COMPANY:	CLASSE AUDIO INC.		
TITLE:	CLASSE 5/5L PREAMPLIFIERS		
DESC:	A.C. LINE & MAIN POWER SUPPLY; LEFT CHANNEL POWER SUPPLY		
DRAWING NO:	5PS-1		
DRAWN:	DJR	DATE: FEB.15/91	SHEET: 1 OF 5

COMPANY:	CLASSE AUDIO INC.		
TITLE:	CLASSE 5/5L PREAMPLIFIERS		
DESC:	PHONO POWER SUPPLY; MOVING COIL PHONO		
DRAWING NO:	5MC-2		
DRAWN:	DJR	DATE: FEB.15/91	SHEET: 2 OF 5

DRAWING NO: 5BUF-4

COMPANY:	CLASSE AUDIO INC.		
TITLE:	CLASSE 5/5L PREAMPLIFIERS		
DESC:	LINE STAGE		
DRAWING NO:	5LS-5		
DRAWN:	DJR	DATE:	FEB.15/91
		SHEET:	5 OF 5

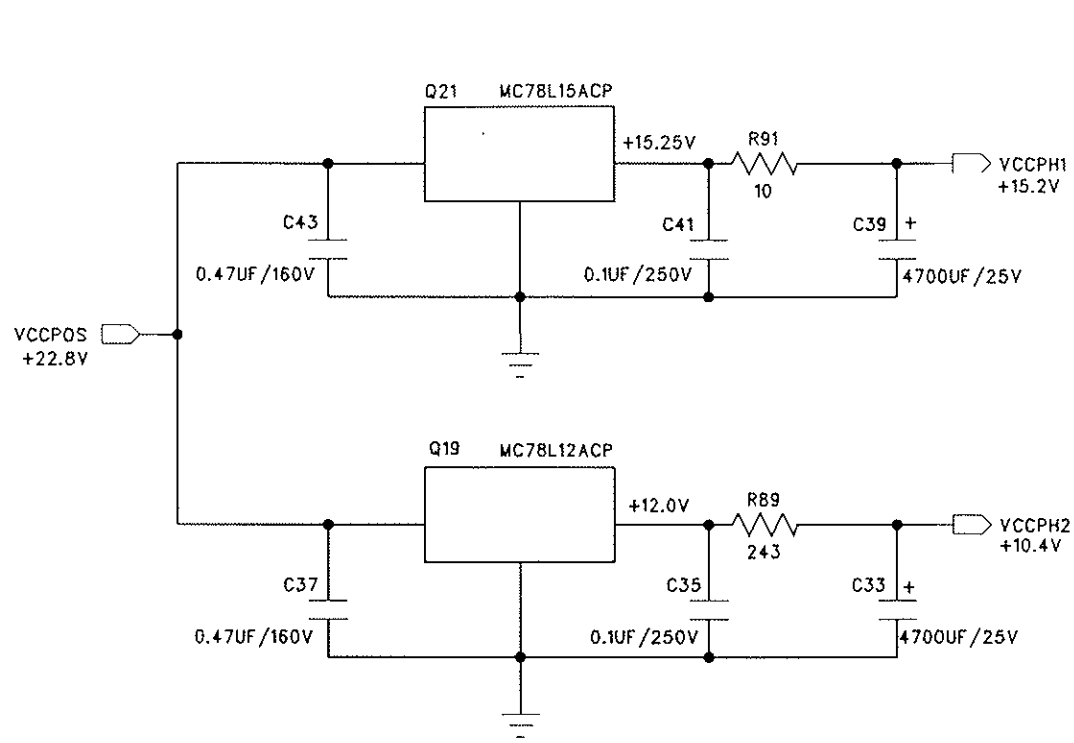
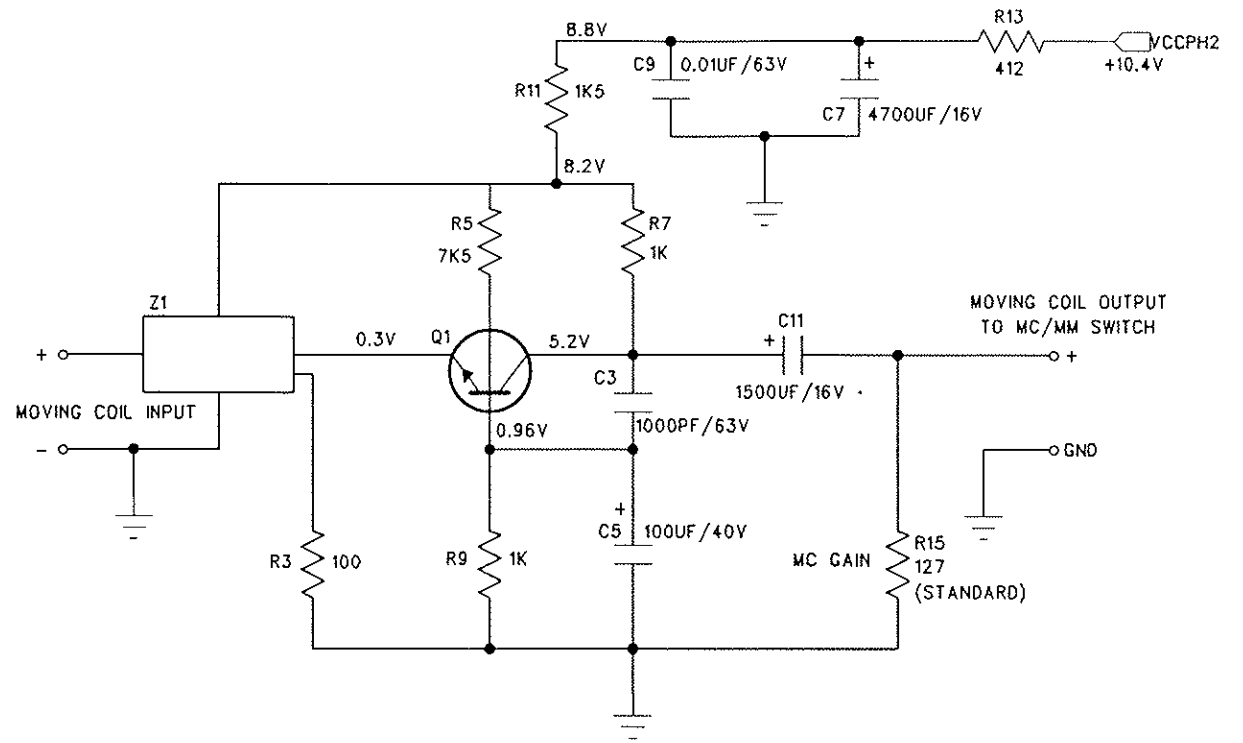
PART NUMBER	WAS	IS	DATE
C3	3300PF/63V	1000PF/63V	JUL. 9/91.

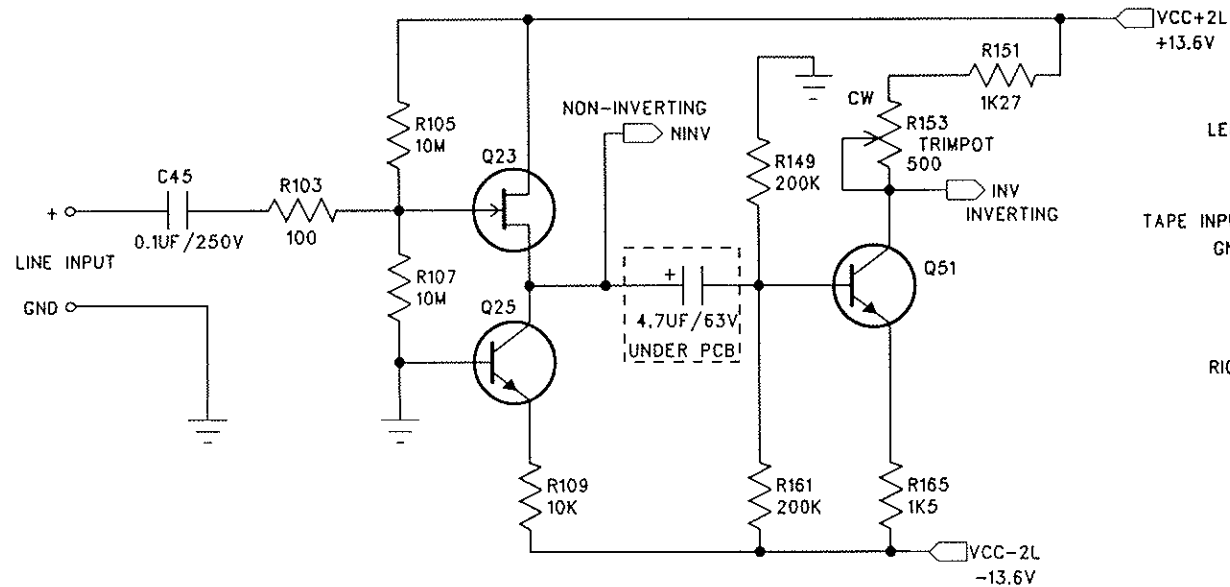
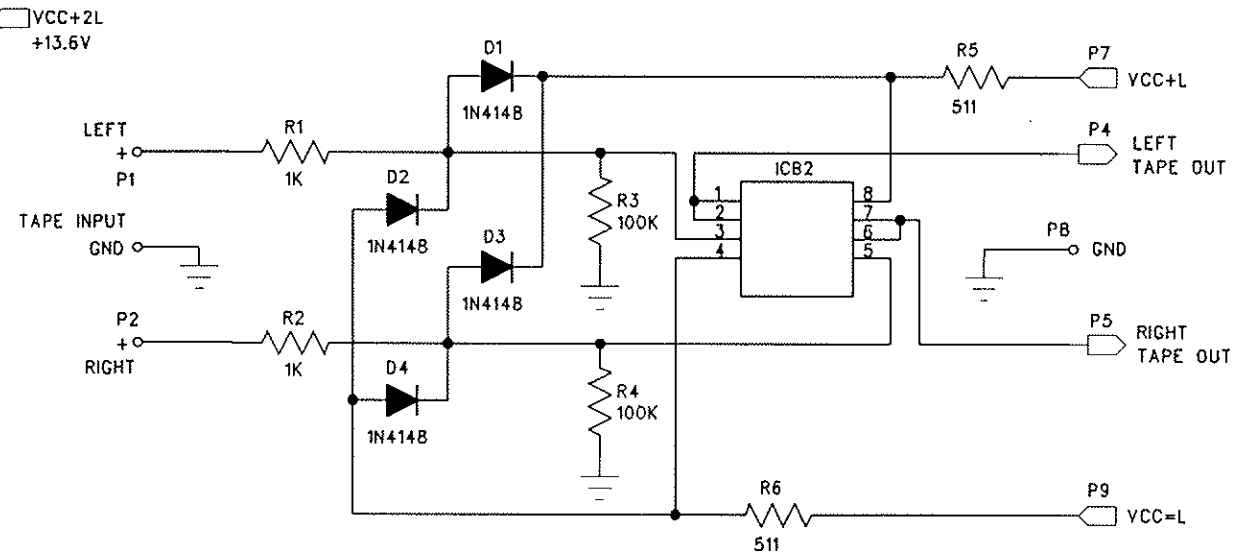
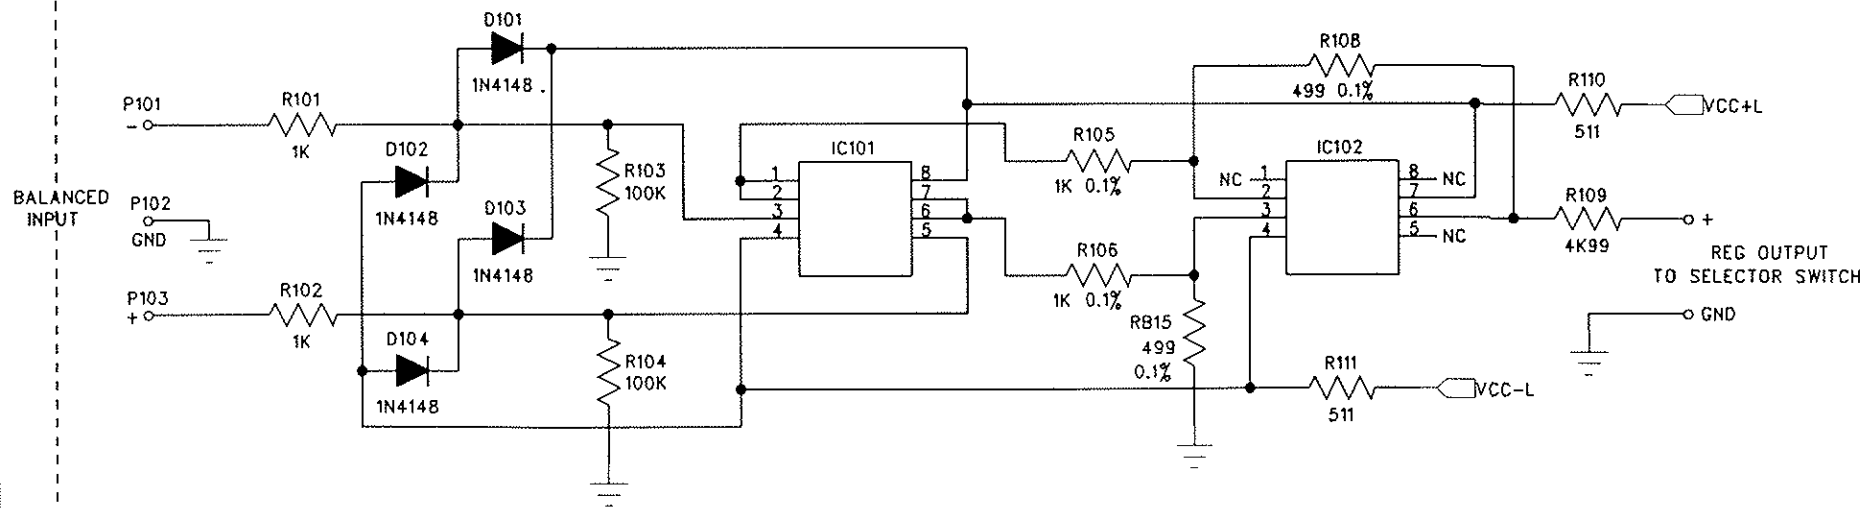
PART NUMBER	WAS	IS	DATE
R157	100K	NOT USED	JULY 9/91.
R149	NOT USED	200K	JULY 9/91.
R161	10K	200K	JULY 9/91.
UNDER PCB	10UF/63V	4.7UF/63V	JULY 9/91.
	ADD TAPE OUT BUFFERS		MAY 15/92
